**Planned Unit Development — Lot 2 Southport East
Replat Two—CPM-SFI Southport, LLC**

RE: Planned Unit Development – Initial Review Letter
Lot 2 Southport East Replat Two

Comment Response: Lot 2 Southport East Replat Two

RE: Planned Unit Development – Second Review Letter
Lot 2 Southport East Replat Two

SHEET
C2.1

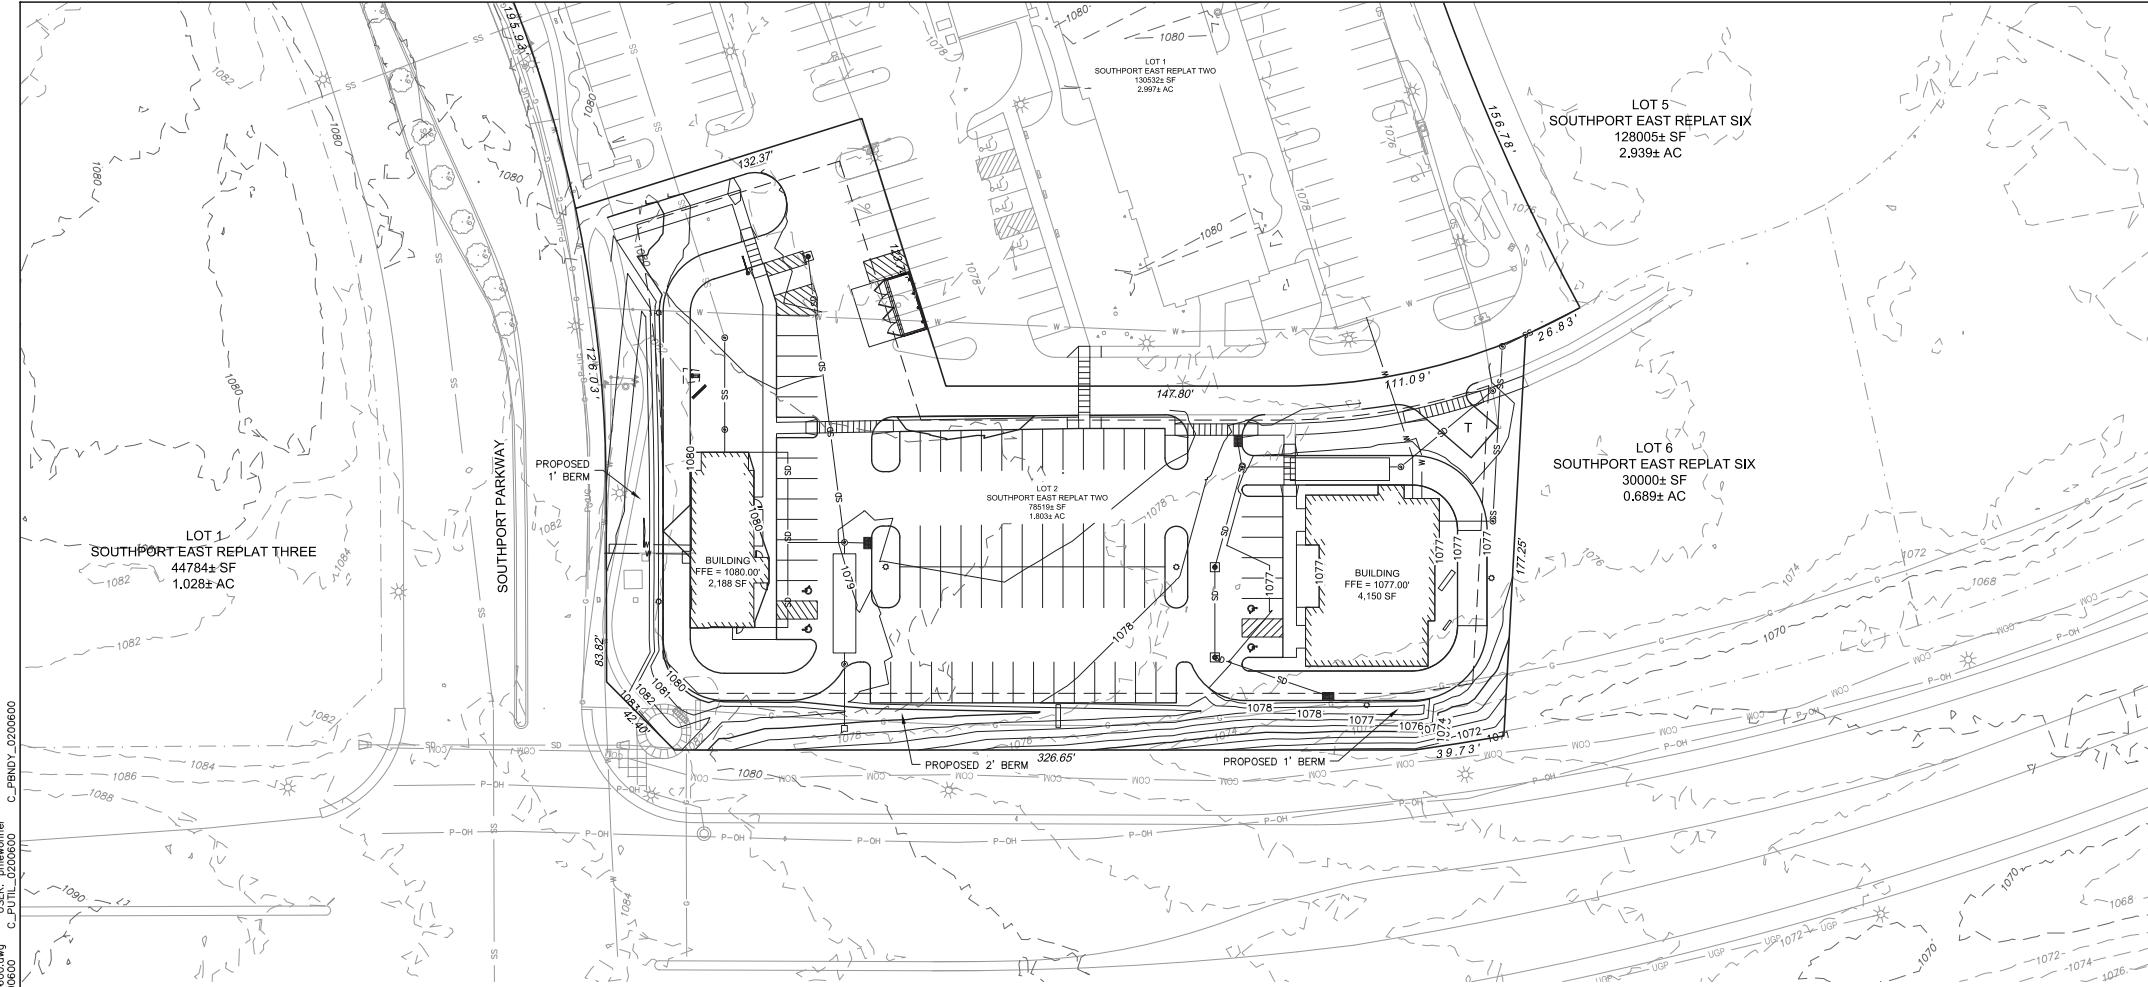
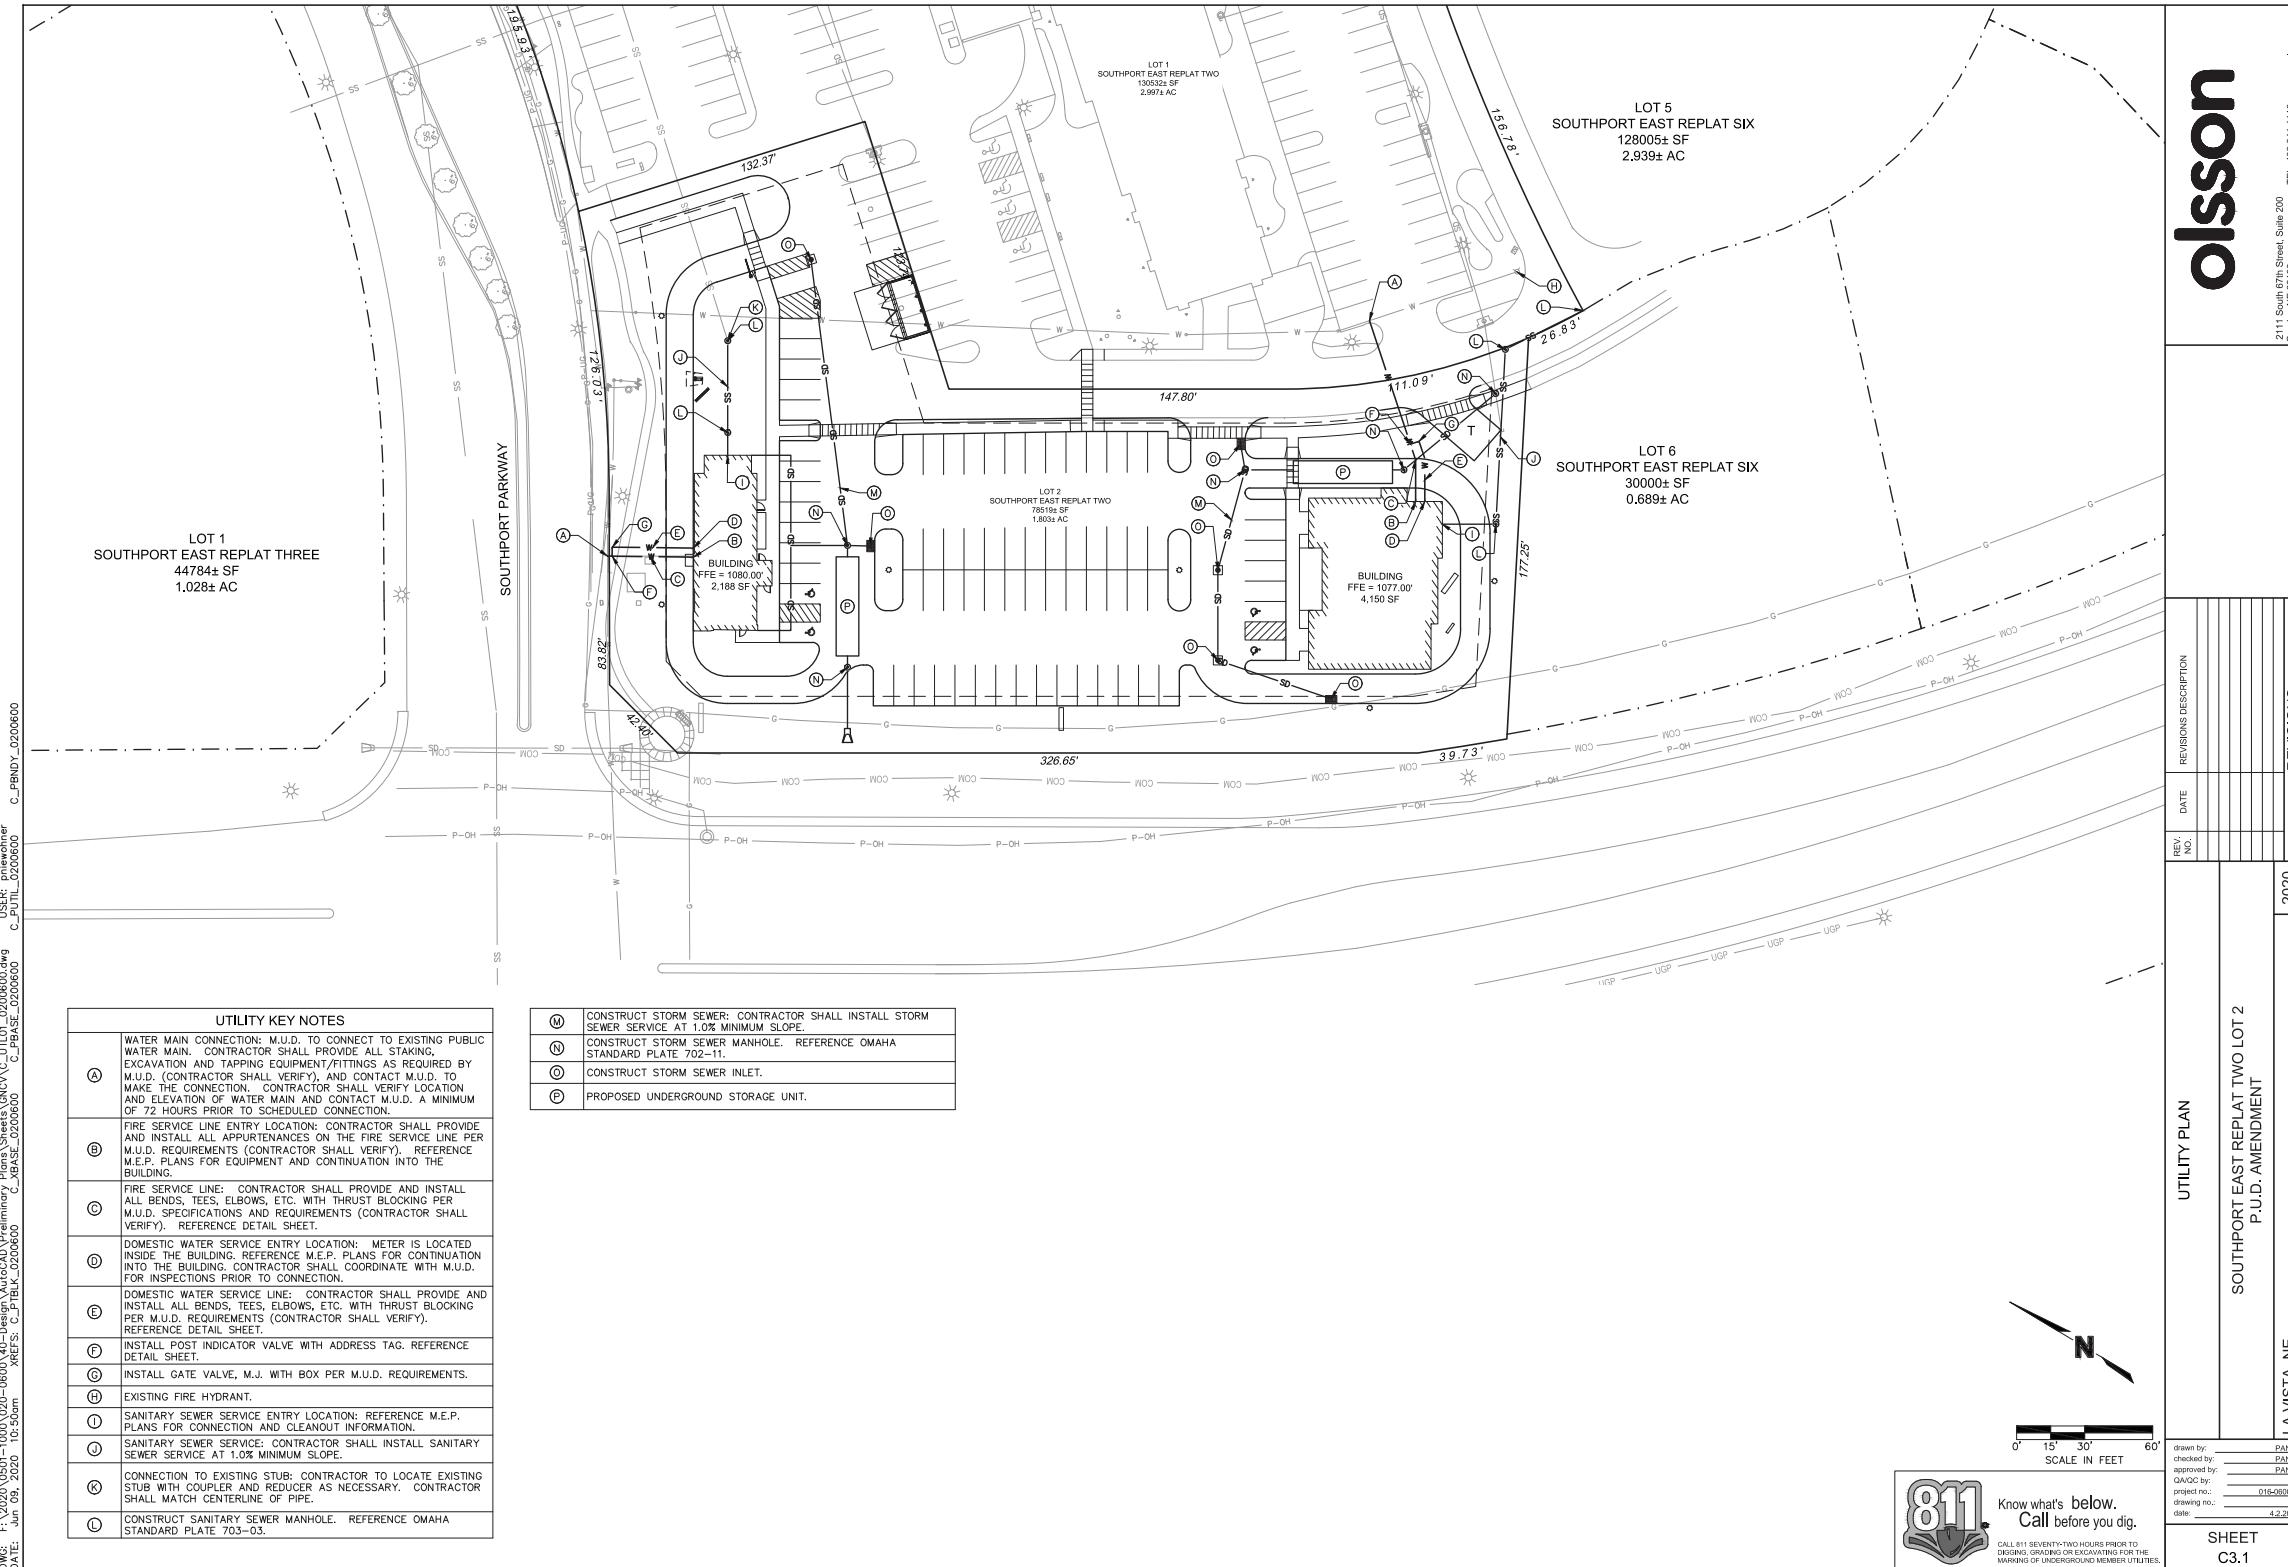
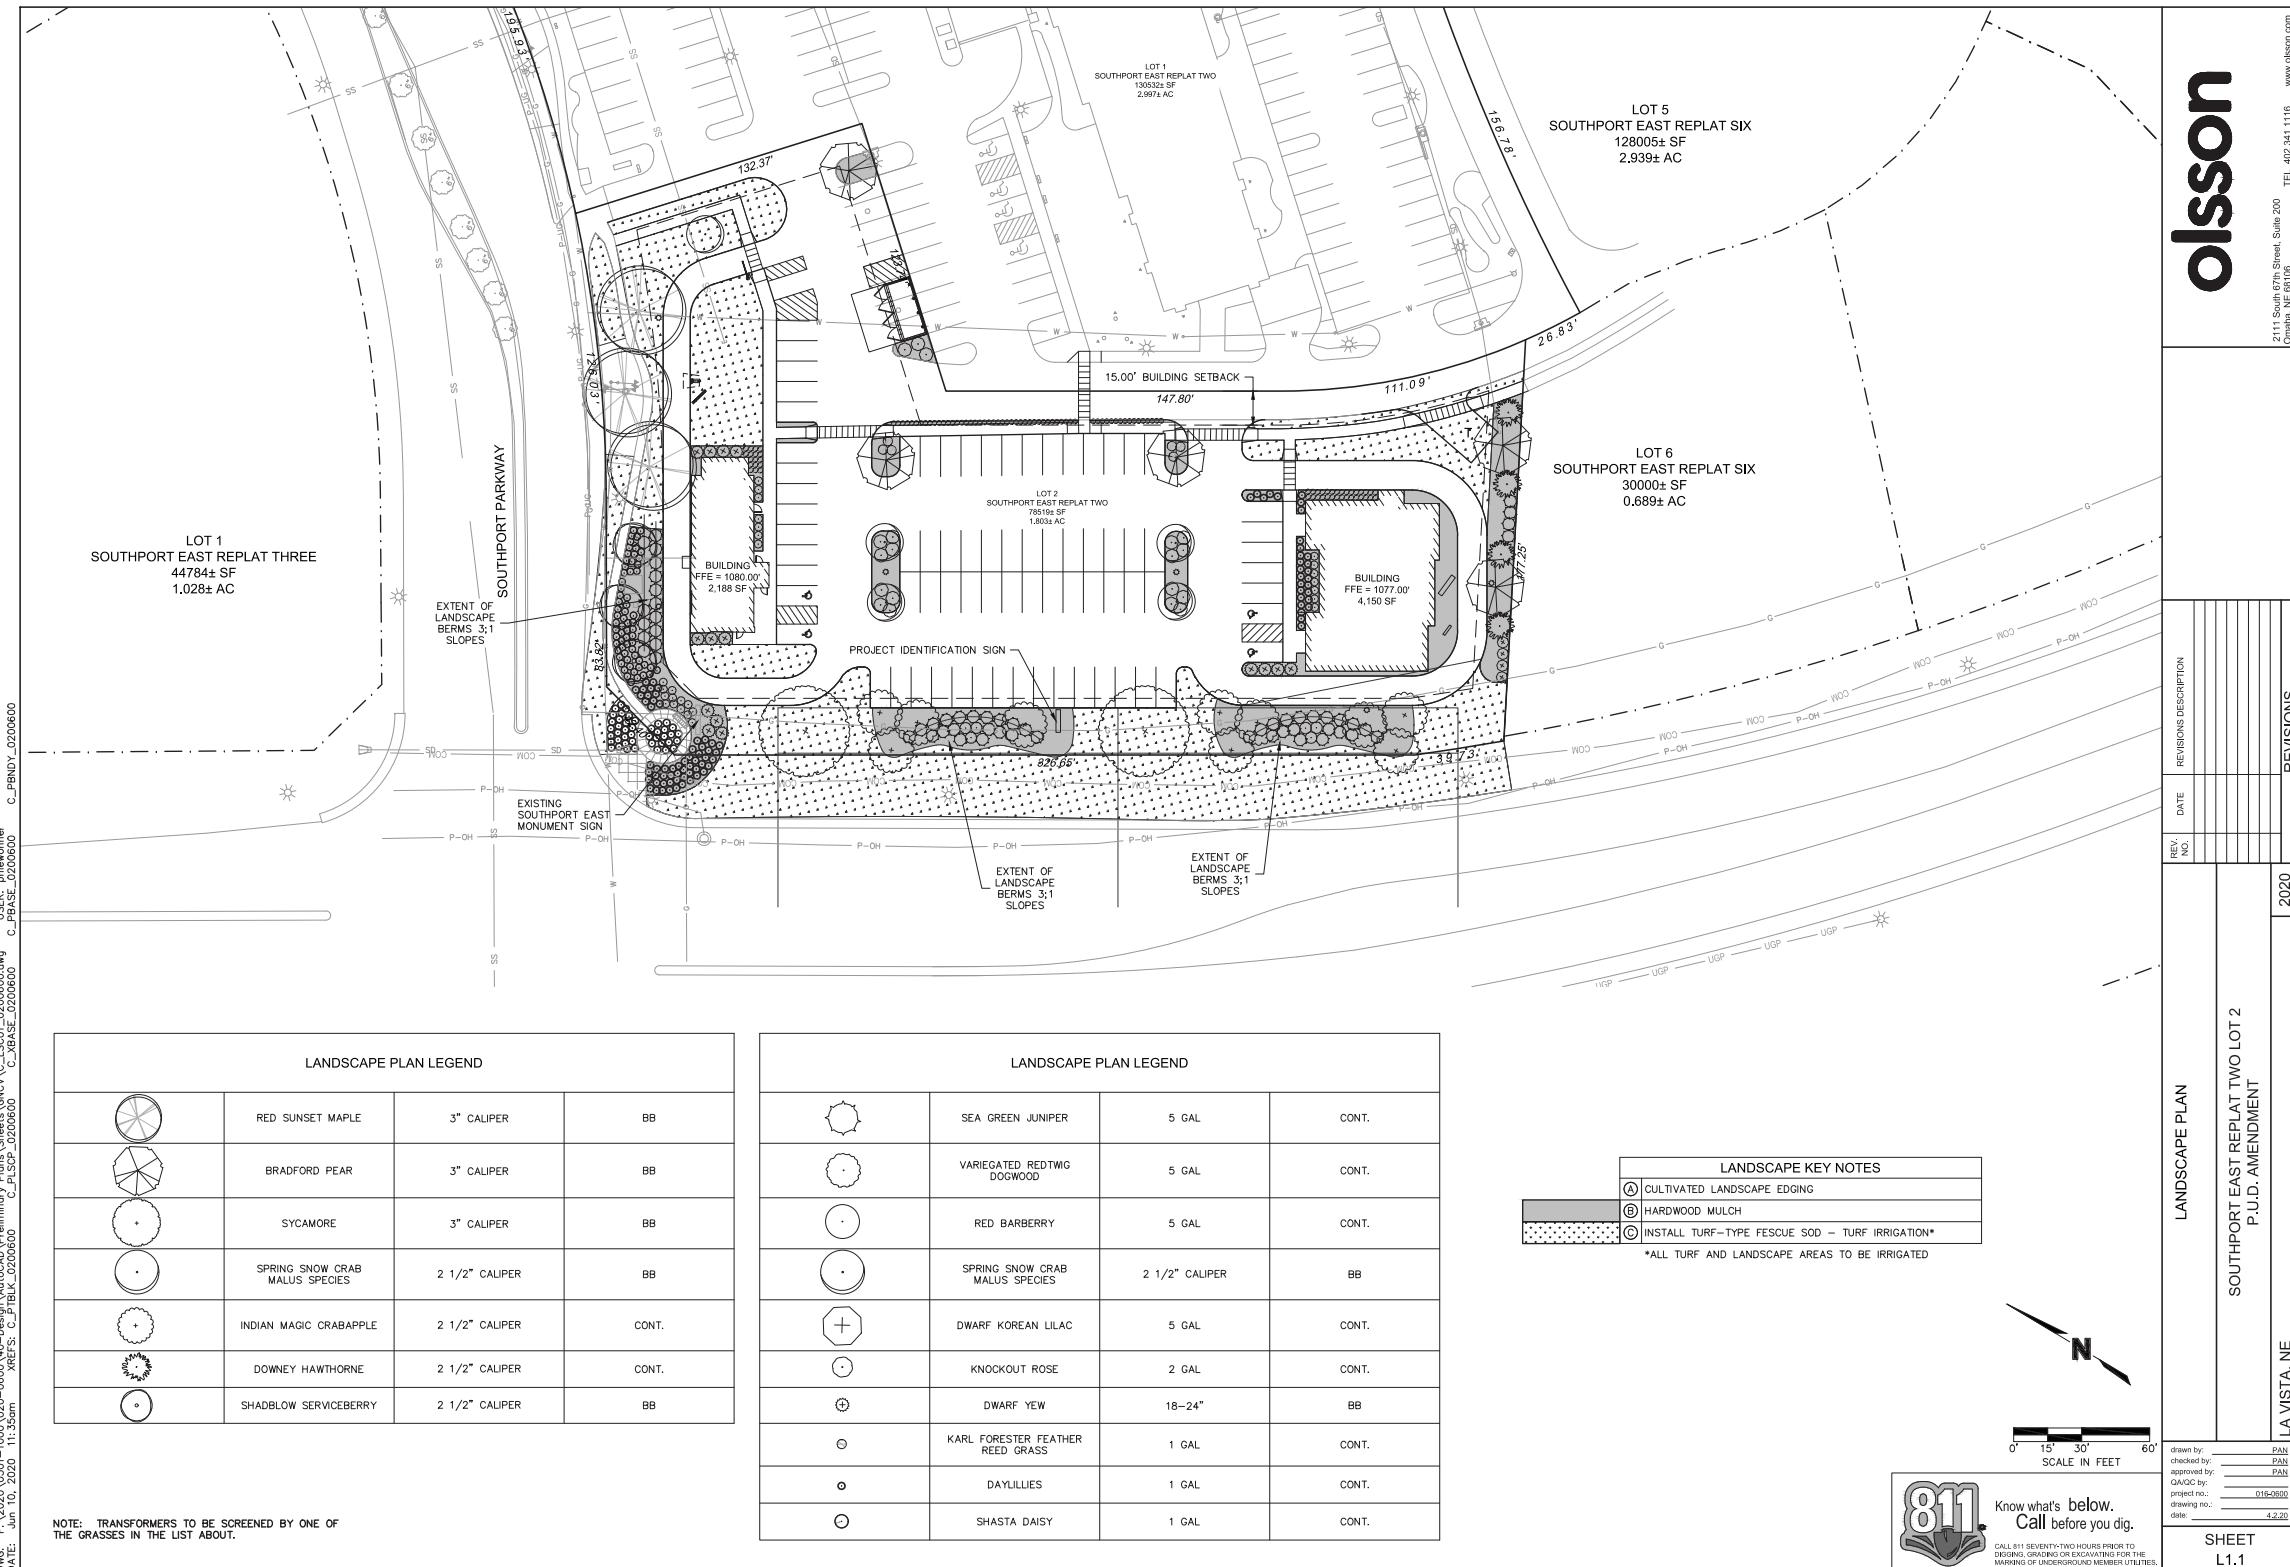
- Grading plan needs to address a conceptual design of water quality and 2-year peak flow detention, such as indication of bio-basins or under parking lot facilities.

- The grading plan submitted does not depict the required berthing of the landscaped areas along Southport Parkway and Giles Road as per the Southport East Design Guidelines.

- Note #4 suggests the proposed grades are in 2' contours, whereas it appears the proposed contours are 1'. Please clarify.

- Labels were added to the grading plan to denote either a 1' or 2' berm along the street frontages, however, the topographic lines do not reflect this berming. Please correct the plan's topographic lines to accurately reflect the berming.

Response: Location of proposed underground detention is shown on sheet C3.1, which will address both water quantity and quality requirements.

Response: Berms are shown on C2.1, although may have been hard to see. Additional information has been added.

Response: Note has been updated for clarity.

Response: Grading has been updated to more clearly reflect this berming.
